Subject: RESPONSE TO REQUEST FOR ADDITIONAL INFORMATION
Re. APPLICATION FOR LIMITED CONTINUED USE OF THE MODEL No. 1500 PACKAGE,
CERTIFICATE OF COMPLIANCE No. 5939

Re: Comparative Analysis: NPI Cask, Model NPI-20WC-6MKII, ES 10-160B, GE 1500, and AOS 100AS

**SHIELDING ANALYSIS FOR NPI CASK NPI-20WC-6MKII
RELATED TO OPERATOR EXPOSURE FOR USE OF CASK**

J. L. SHEPHERD and Associates			
DRAWN BY D. TRAN	DATE 21FEB12	APPROVED BY <i>DTS</i>	SCALE FULL
200 Ci & 6,500 Ci CAPSULE DETAIL			
MODEL 484		A-0484-W3799-CAD-1

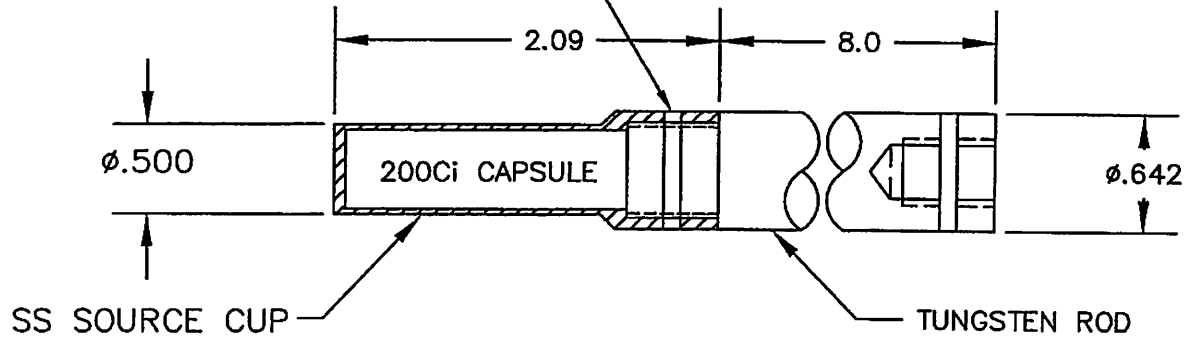
Intended shipment consists of three Cobalt 60 radioactive sources. Two sources are 9,500 Curies each; the third source is 200 Curies. All three sources are Sealed Sources configured per Drawing Number A-0484-W3799-CAD-1, attached hereto. Each of the 9,500 Curie sources, when configured for shipment measures approximately 13.700" in length and has an extreme diameter of approximately 1.142". The 200 Curie source has an overall length of approximately 10.1" and an extreme diameter of approximately 0.642".

As configured, the sources are locked onto the tungsten rods by roll pins which cannot be removed and re-installed in field locations. Installation of the tungsten rods and roll pins occurs in hot cells during capsule fabrication. The lengths of the tungsten rods are considered the minimum necessary to avoid the risk of handling exposure during installation/removal from transport shields and devices.

J. L. SHEPHERD and Associates			
DRAWN BY D. TRAN	DATE 24SEP12	APPROVED BY <i>[Signature]</i>	SCALE NONE
9,500 CI LOADING CONFIGURATION			
NPI CASK MODEL S/TC MKII		A-0147-NPI-LC-2

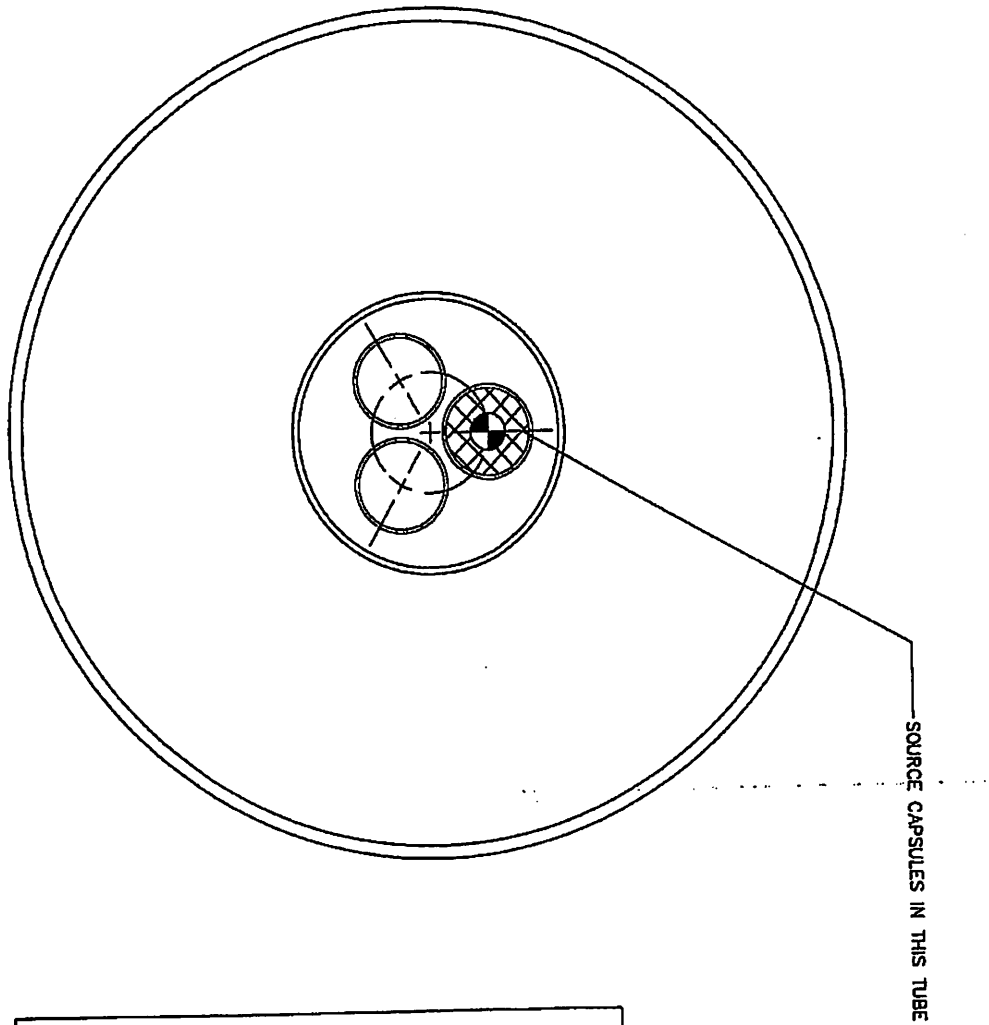
Additionally, the design of the NPI cask and shield, with insert as shown in Drawing A-0147-NPI-LC-2 (as received from NPI) prohibit achievement of low output readings due to the need to carry the source assembly off-center. The NPI shield is not designed for the intended type of source configuration. The intended use of the NPI shield is for transportation of teletherapy sources, typically 2" diameter by 2" long or smaller. The NPI shield when loaded with a 9,500 Curie JLS&A source capsule configured for handling and loading into the customer's device will present a surface reading as shown on the attached drawing of 1.398 R/hr. This high output is due to the source needing to be carried in an off-center vertical alignment, and extension below the center of the sphere, creating a "hot area" on the shield. This amount translates to a TI of 23.

J. L. SHEPHERD and Associates			
DRAWN BY D. TRAN	DATE 24SEP12	APPROVED BY <i>[Signature]</i>	SCALE NONE
9,500 Ci LOADING CONFIGURATION			
NPI CASK MODEL S/TC MKII		A-0147-NPI-LC-1

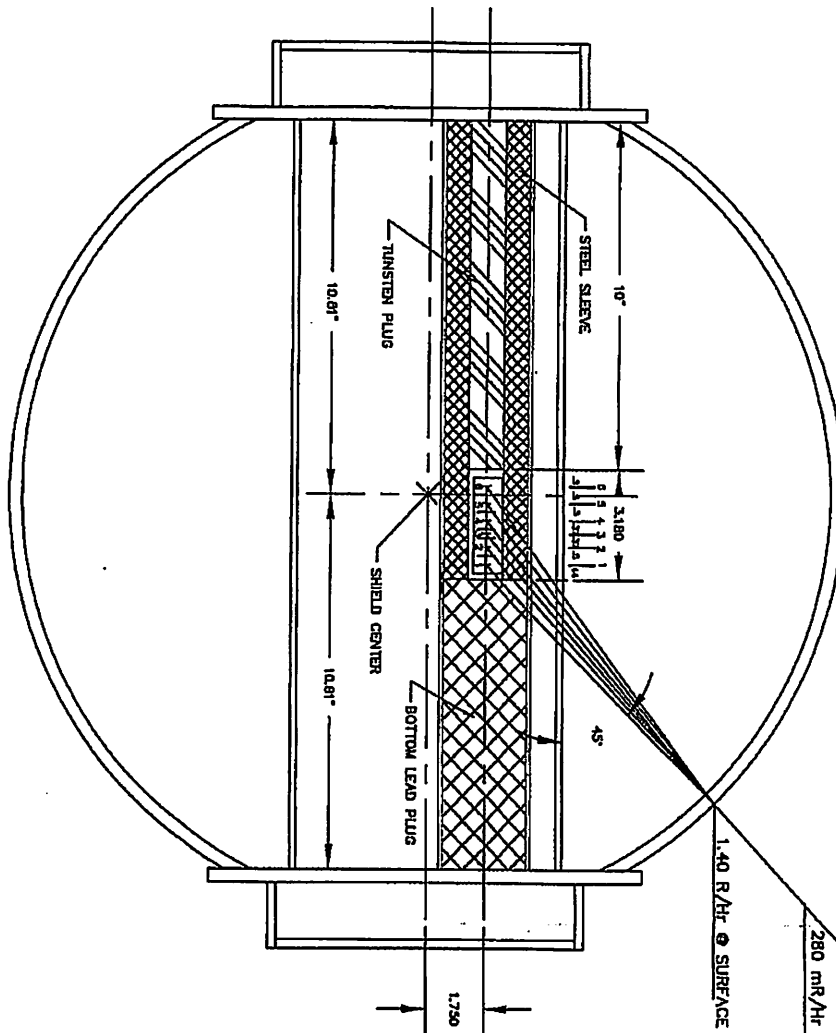
Location: centered in a 2.5" diameter SS tube mounted in Item 5 per NPI drawing 240122 Sheet 1 of 2. In this configuration the source extends 2 7/16" past the centerline of the spherical cask significantly reducing shielding surrounding the source and increasing radiation levels associated with cask usage.

The highest radiation level will be at a point located at a 45° angle from the end of the source. This is shown on the attached drawing.

To determine radiation levels the Co-60 content in the source was broken into 6 segments as shown on the drawing, 5 at 1728 Ci and 1 at 864 Ci. Calculations were made at the center line of each segment.
